CW2144960-A010-0067_R1
1833-05-TQS-8039_0

Site Technical Query - Form

TQ Number:		Project:	
CW2144960	-A010-	0067	Oyu Tolgoi Underground Project
A. To be completed by or on behalf of the Contractor			
Contractor/Sub-Contractor Name:	MCS International	Date Response	23/02/2022
Contract Title:	Booster Fan installations	Plant Area &	1833
Contract No.	CW2144960	Contractor TQ Number:	BF-0415-TQ-0067
Discipline Codes (Mandatory) <input type="checkbox"/> D1 (CSA) - <input checked="" type="checkbox"/> D2 (MP) - <input checked="" type="checkbox"/> D3 (E&I) - <input type="checkbox"/> D4 (Other) - <input type="checkbox"/>			
<i>Description of Technical Query (List affected drawings and specifications):</i> 1833B Fan area : Monorail hoist clash issue The hand chain wheel of monorail hoists (2ea) installed on the monorail beam is clashing with shotcrete ceiling and cable bolt. Refer to the attached field photos.			
<input type="checkbox"/> Routine <input checked="" type="checkbox"/> Urgent Refer Technical Query instructions

Option 2

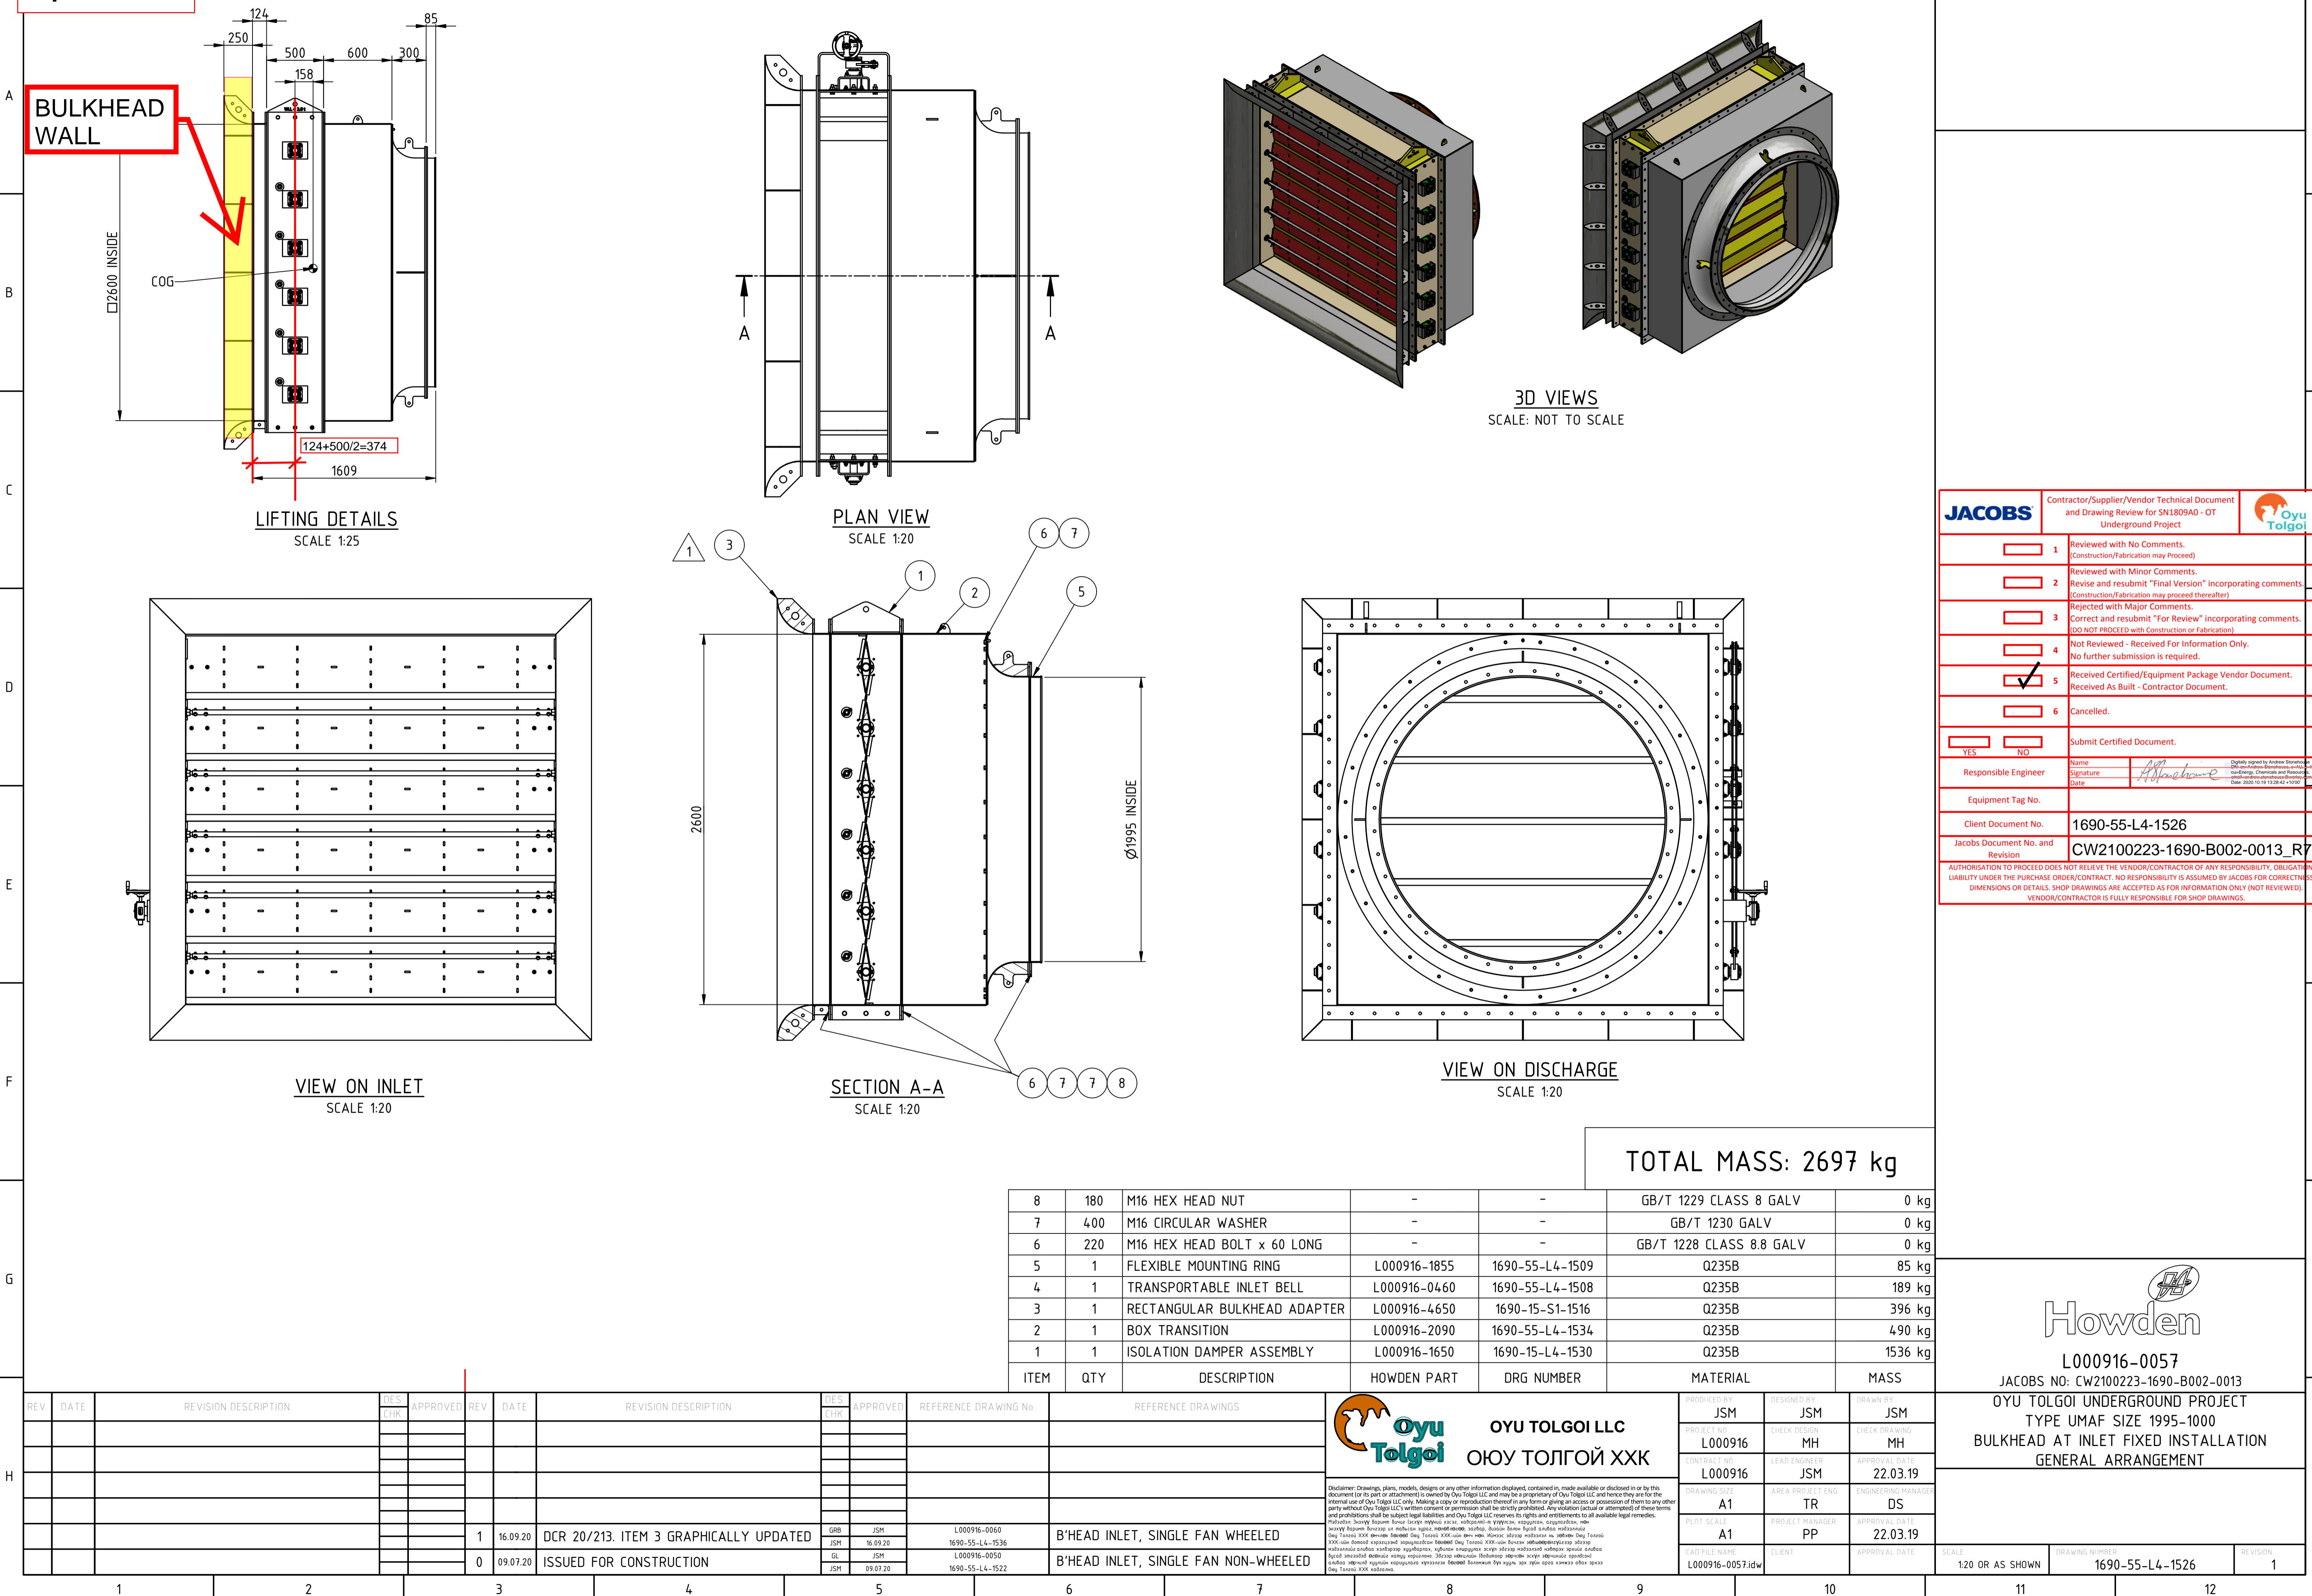
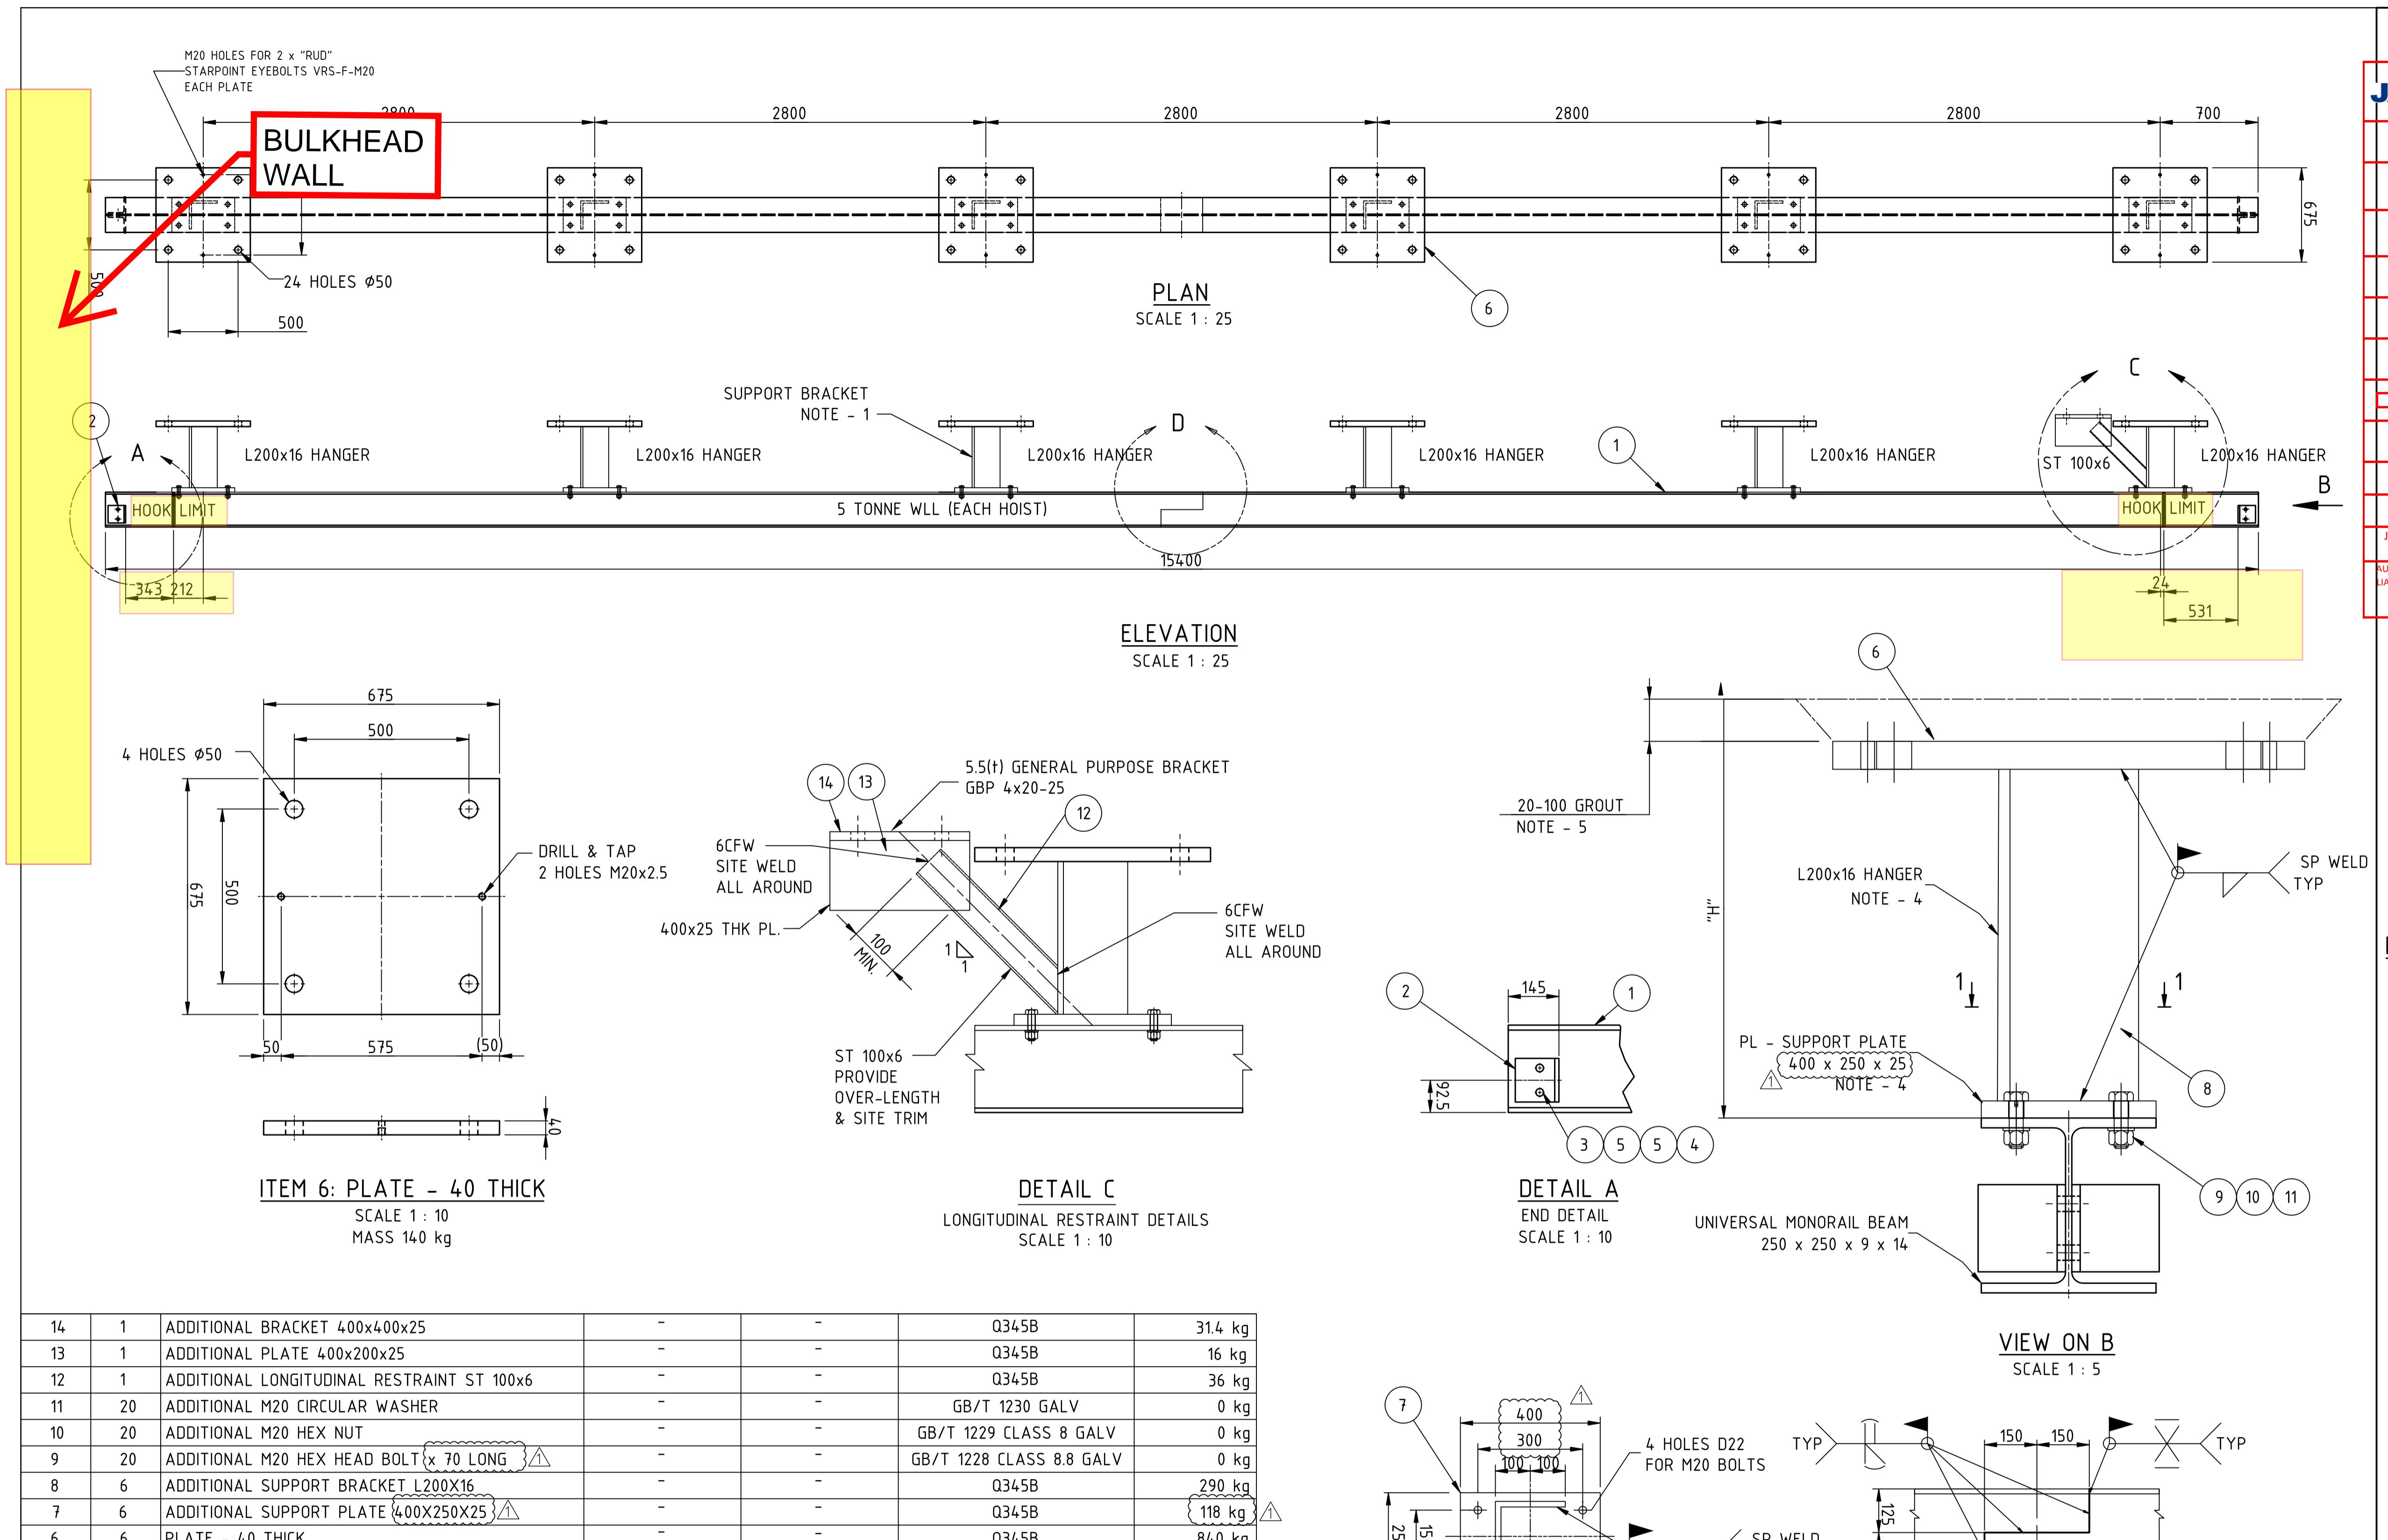
Hook limit changes to approx. 800mm from bulkhead wall
However, lifting lug of isolation damper (which is the closest part of the fan from the bulkhead wall) is 374mm from the bulkhead wall.
